Tesla, Inc. Service Bulletin		Reroute RH Frame Harness	
SB-24-17-002 February 28, 2024			
Classification		Section/Group	Mobile Service
Campaign Bulletin		17 - Electrical	Cannot Perform
Configuration			
All			
Model	Model Year	Country/Region	Build Location
Semi	2022 - 2023	United States	Giga Nevada
The model(s) and model year(s) listed are a general approximation of the affected VIN list. Refer to the VIN/Bulletin Tracker or Customer/Vehicle profile to determine applicability of this bulletin for a particular vehicle.

On some Semi, the RH frame harness may rub against the thermal hose stud, which may damage the harness over time. Harness damage may result in Anti-Lock Braking System (ABS), traction control, and stability control alerts.

Inspect the vehicle for symptoms related to the condition. If symptoms are present, perform wire repairs (if necessary), and then reroute the RH frame harness.

Figure 10 – RH frame harness inspection area

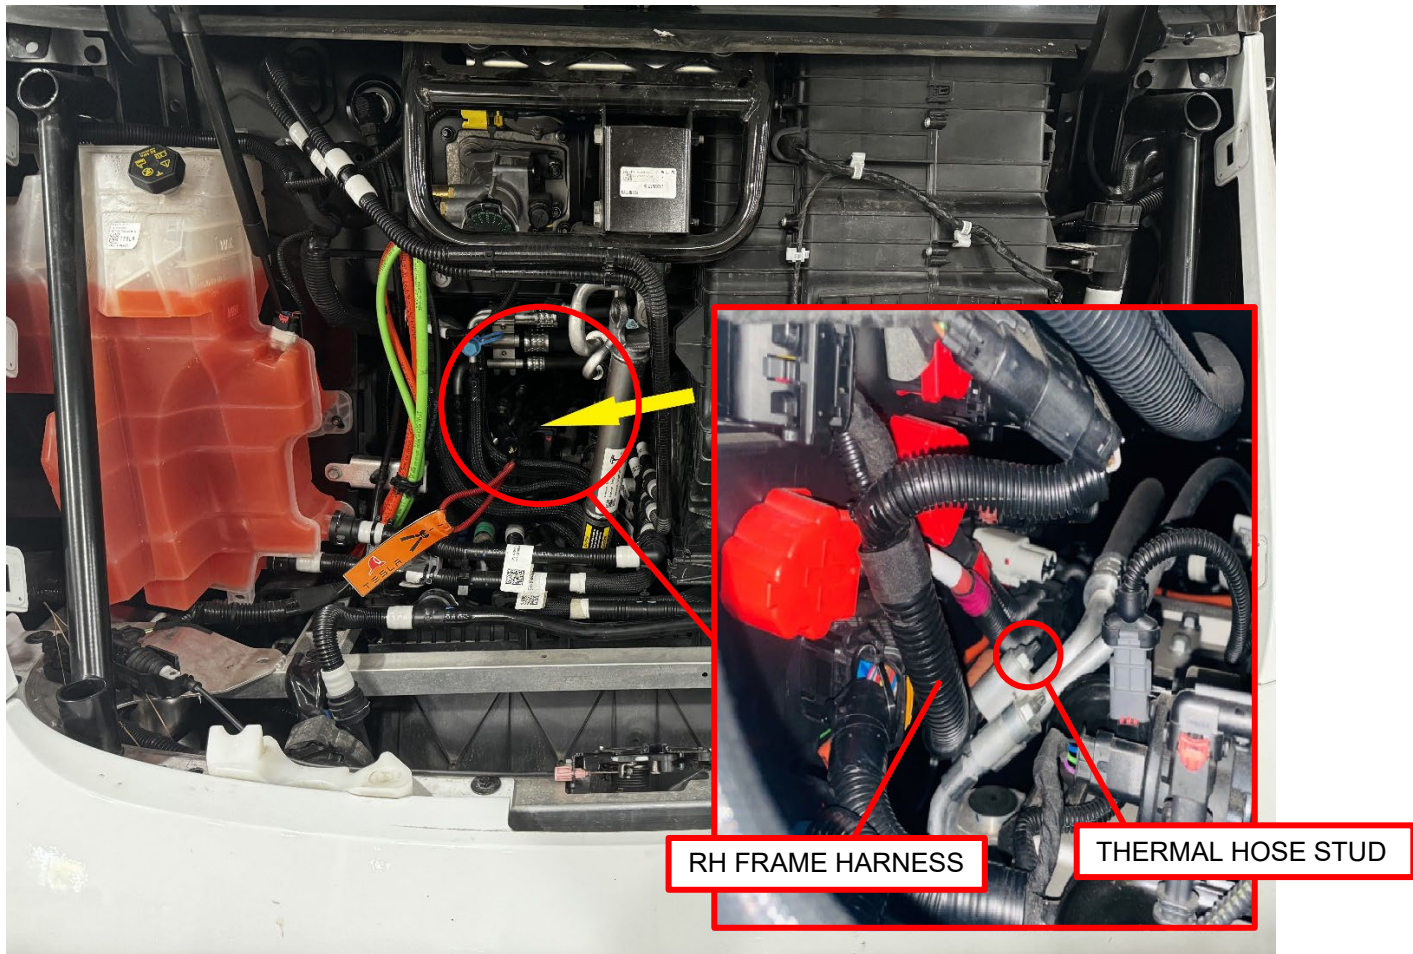
5. Inspect the RH frame harness for indications of damage or rubbing against the thermal hose (Figure 10).

Figure 14 – Evidence of damage observed (2 of 2)

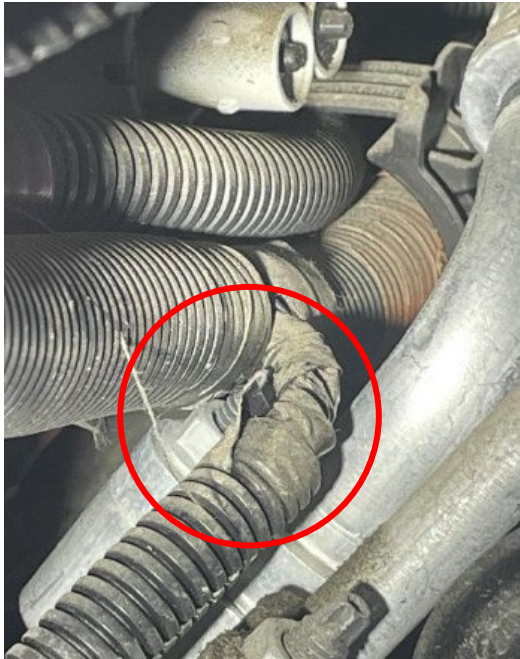
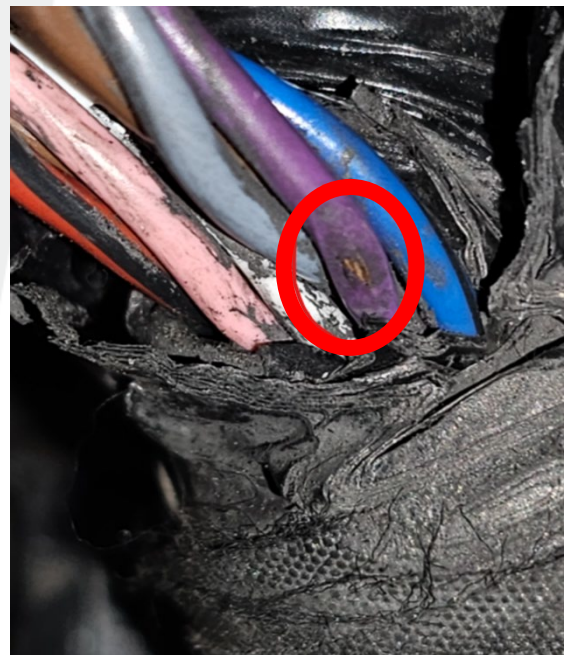
- If evidence of damage or rubbing between the harness and thermal hose stud is not observed, skip to step 6.
- If evidence of damage or rubbing between the harness and thermal hose stud is observed (Figures 11 through 14), perform the following steps:

- Create a Toolbox session.
- Record the harness in question and description(s) of the rubbing or damage observed to the Toolbox session. Escalate the Toolbox session, wait for additional support, and then continue to step 6.

Figure 15

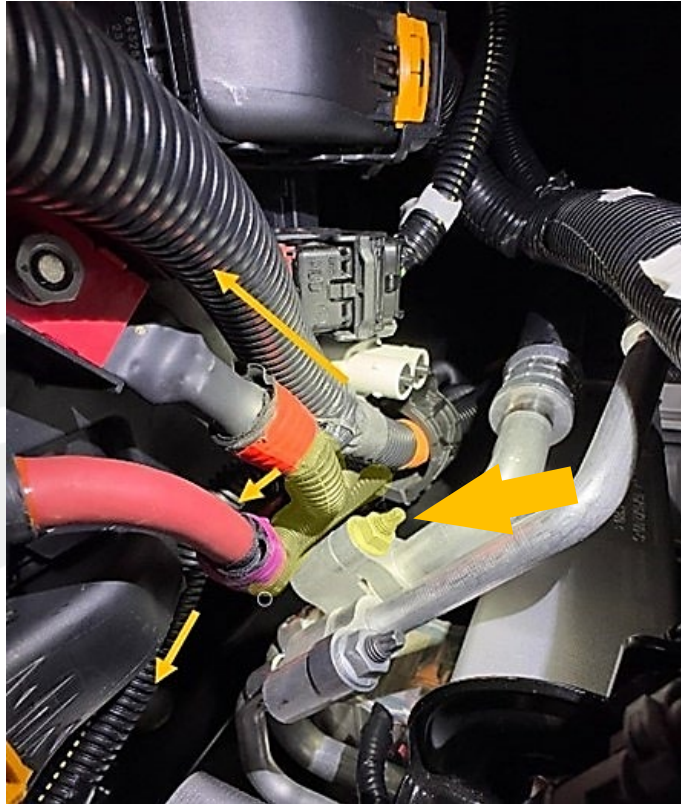
- a. Position the RH frame harness away from the thermal hose stud and arrange the harness as shown in Figure 15.

Figure 16
TESLA

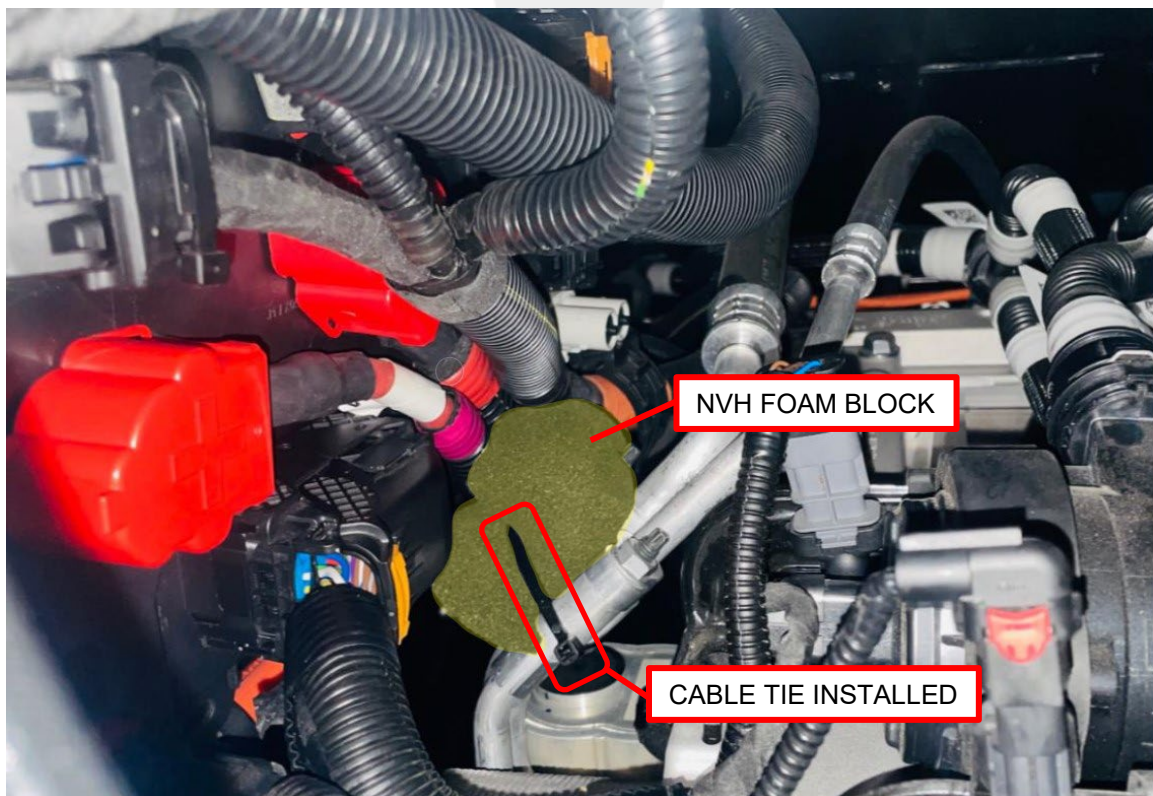
- b. Position a Noise, Vibration, and Harshness (NVH) foam block between the RH frame harness and the thermal hose stud, and then use a cable tie to attach the foam block to the thermal lines (x2) (Figure 16). Cut excessive tie from the cable tie.
